Cable tray installation/modification and rack area modifications for RE4 Signal cables

Ian Crotty 12, 19, 21, 23,28 Aug 2013

X2J52

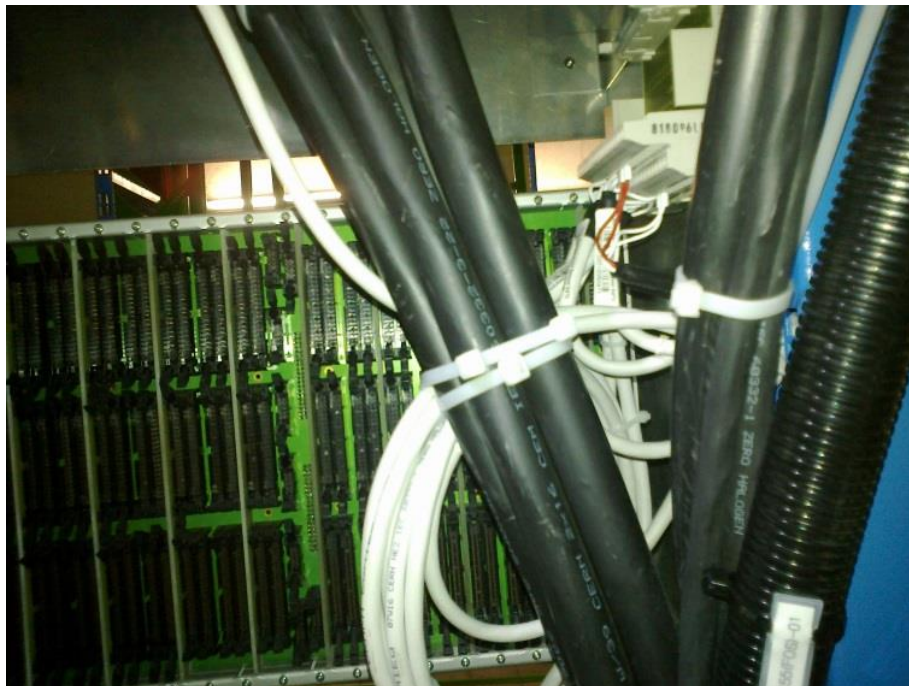
Cable tray to be lowered or a wider one put in. The protection around the newly enlarged hole must be installed. Maf should have received the edge trim.

And an extension done across this gap. Approved by 904 Intergration.

CSC power cables to be moved.

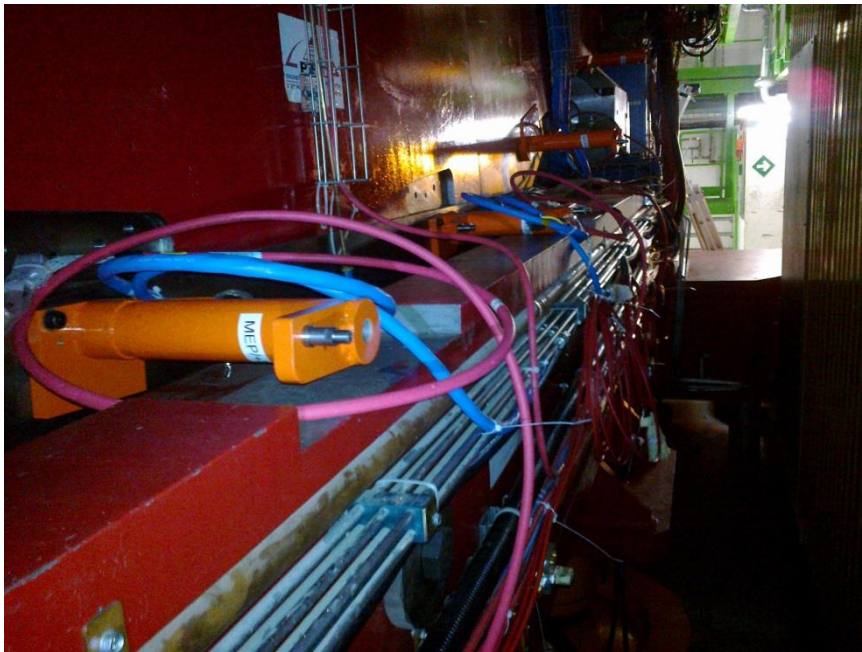
Lowering the crate will make the access to back plane more painful. This is the reason it was put high up, otherwise the crew will be on their knees in a 40cm gap.

X3J51

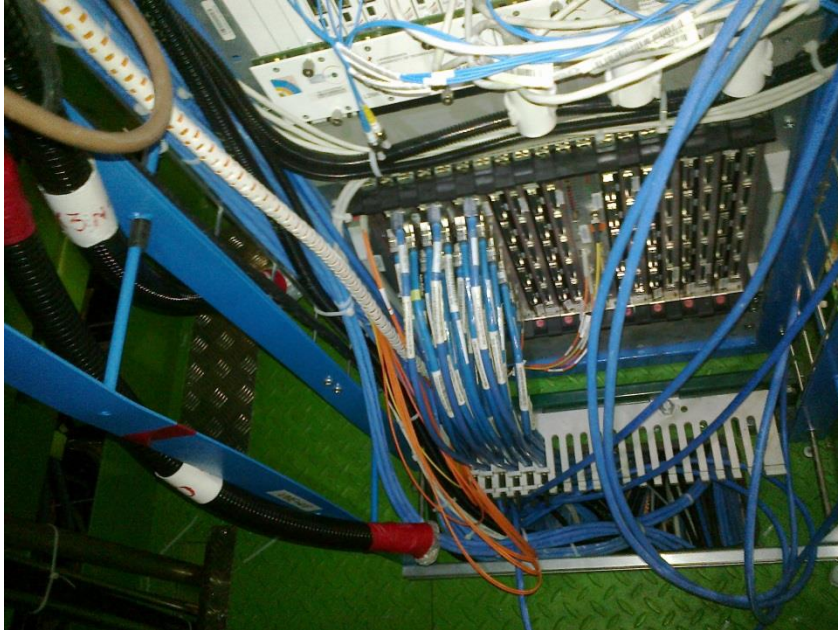
Trigger boxes, (Black and Alu) to be moved away from the backplane.

We will need a cable tray 200mm wide installed under the rack floor under the present one.

Complete trim around newly enlarged holes to be fitted .

Cables on the front of the rack from Trigger LV will have to be moved to the side of the floor access

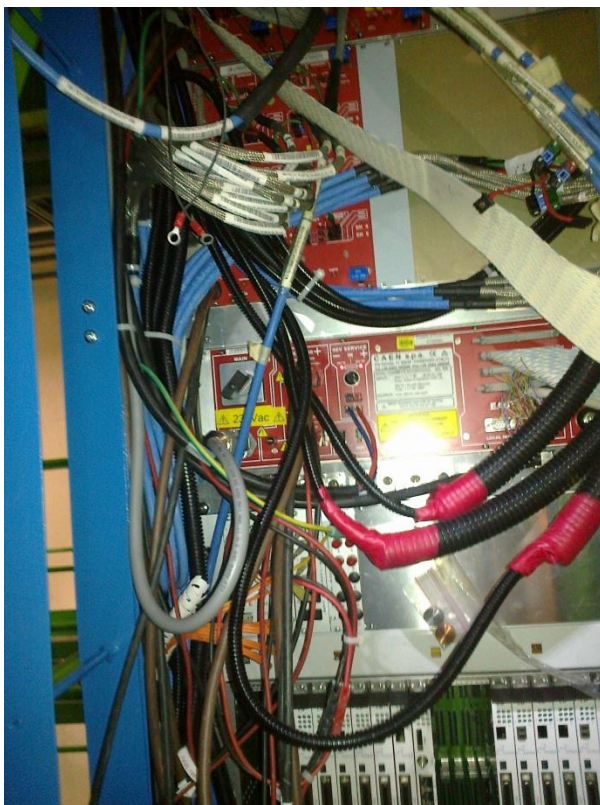
Hole AND will not cross the cable tray. One solution is to remove the cables so that the CSC can do the cabling to the entire width of their rack and then replace the cables under the rack, OR more easily over the top of the rack.

There are fibres that will also have to be moved to allow CSC cabling. Cabling shown below will be tidied.

X4J51

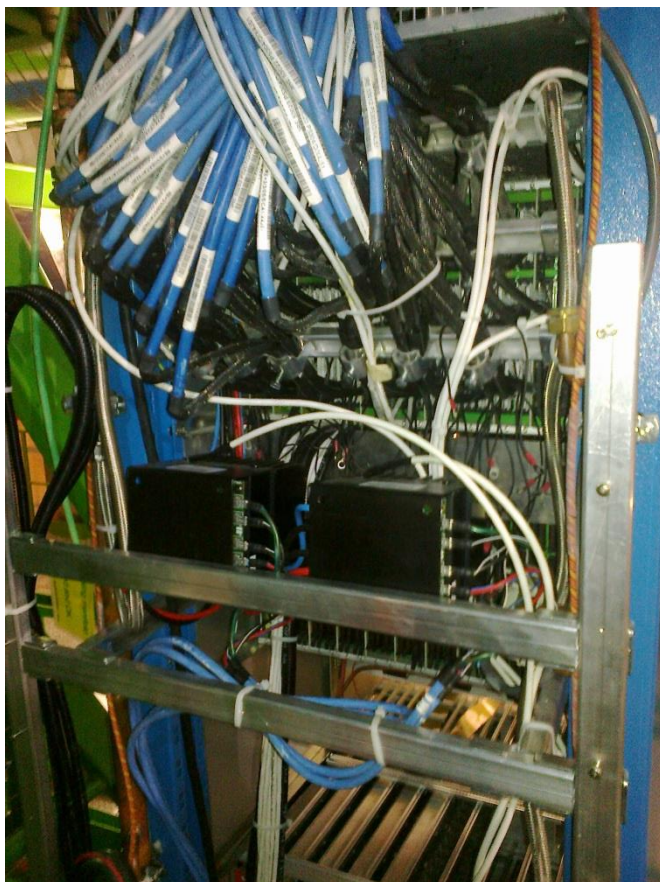
An additional cable tray installed under the present one BUT above the CSC aluminium junction boxes.

In addition the black boxes mounted at the rear of the rack block access to the LBB back plane.

They must be removed . If possible they can go back after the signal cable installation.

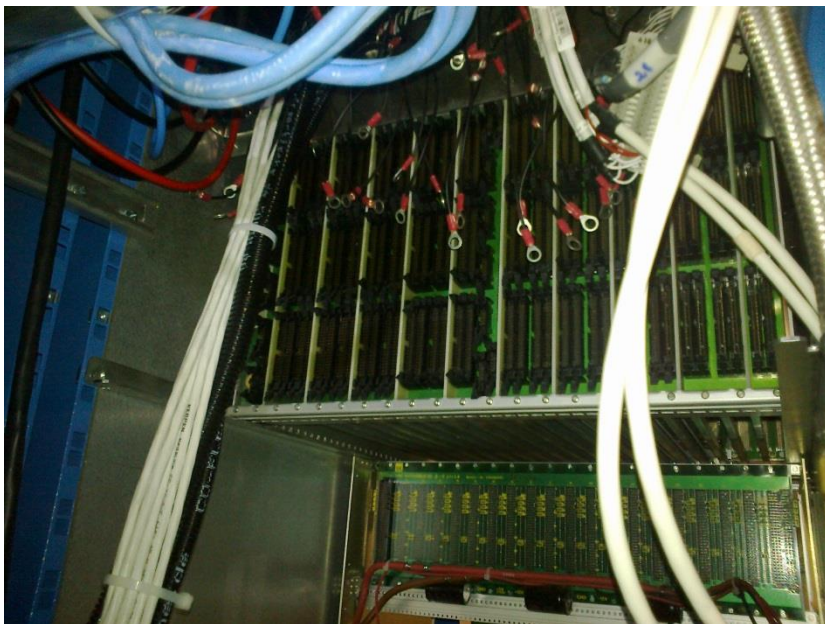
Perhaps this cable on the left should be moved aside.

Cables going through the rack should not be taken as an acceptable path. Instead they should be taken above or below the rack as circumstances dictate. See below.

X2A52

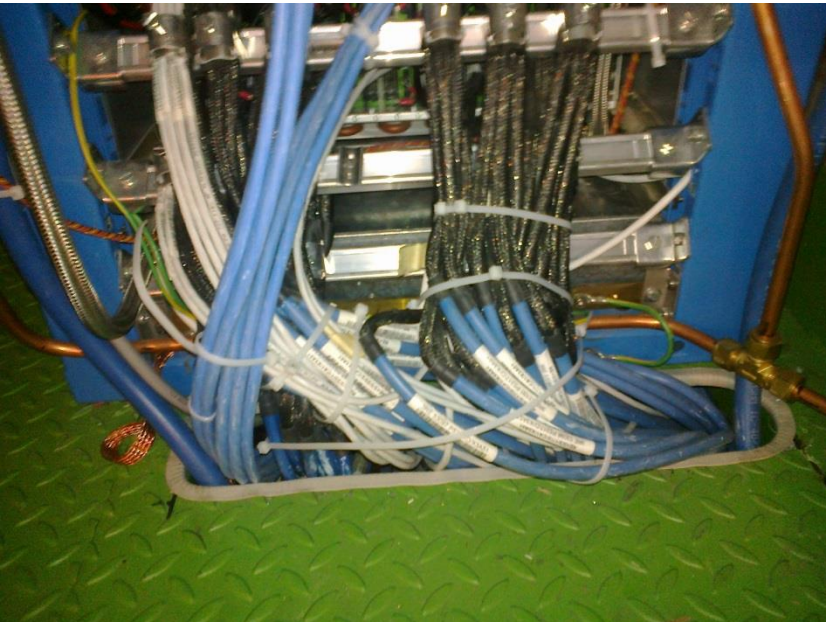
An additional cable tray to be installed directly on top of the rack or 10 cm above but UNDER the square section green beam, all the way across towards the beam above the copper gas piping.

X3A51

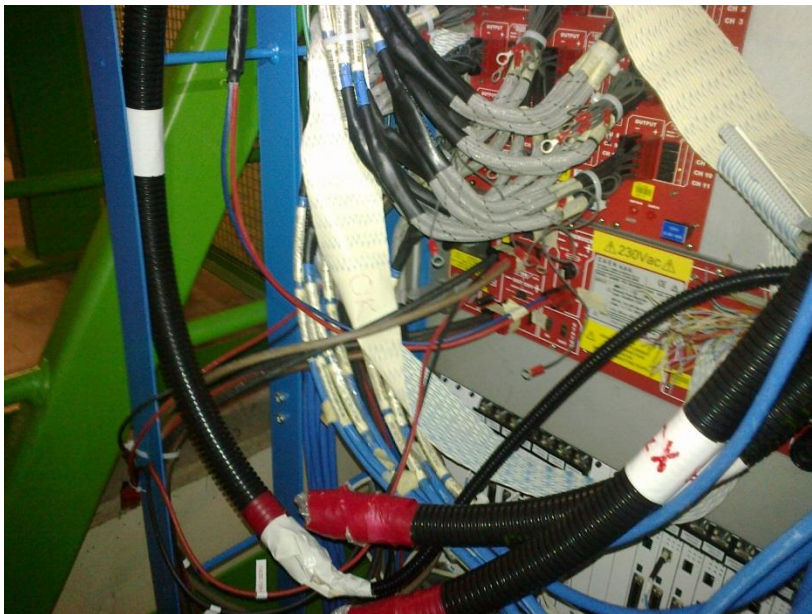
The hole in the floor is now almost twice as large. Trim must be completed.

Here we need a new cable tray just under this one BUT starting from the back of the rack. This will allow the big red CSC cables to be cabled correctly. See 2<sup>nd</sup> photo.

This Trigger box needs to go somewhere else.

The cabling in this rack must be cleared up, it seems to primarily concern the cables for the trigger.

Disconnected control cable (50c flat Cable)

and unused 48V service power.

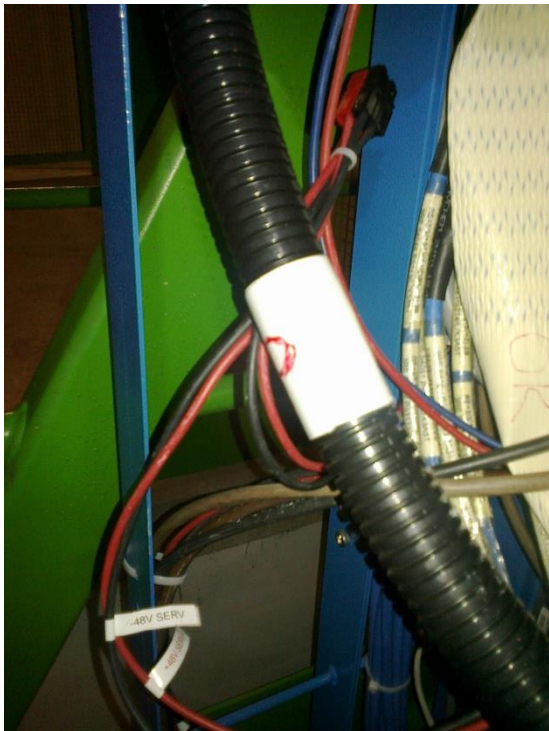
Black power cable in front of CSC crates.

X4A51

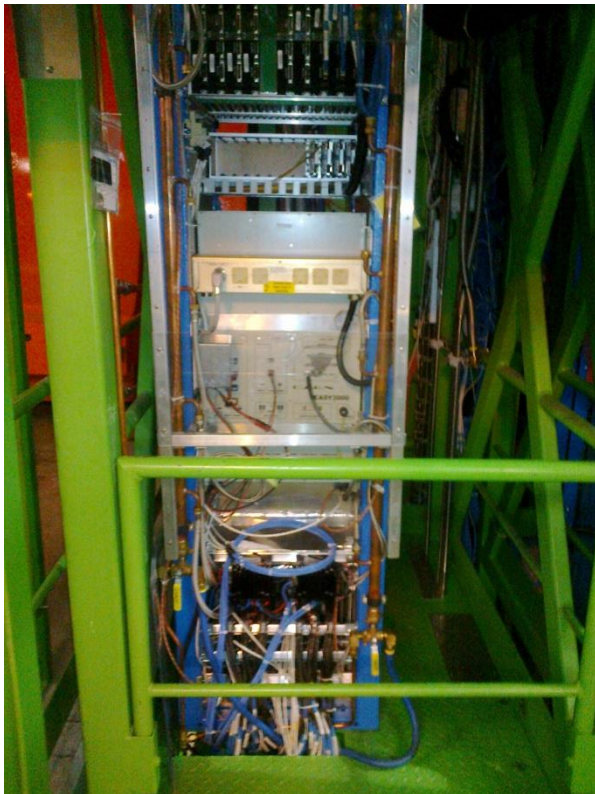
An additional tray will be installed under the present one BUT above the Aluminium CSC junction boxes. Identical to the Near X4J51.

The cabling at the top of the rack is poorly done and now will limit access to the additional RE4 cabling tray. Behind the panel shown below the black boxes have to go.
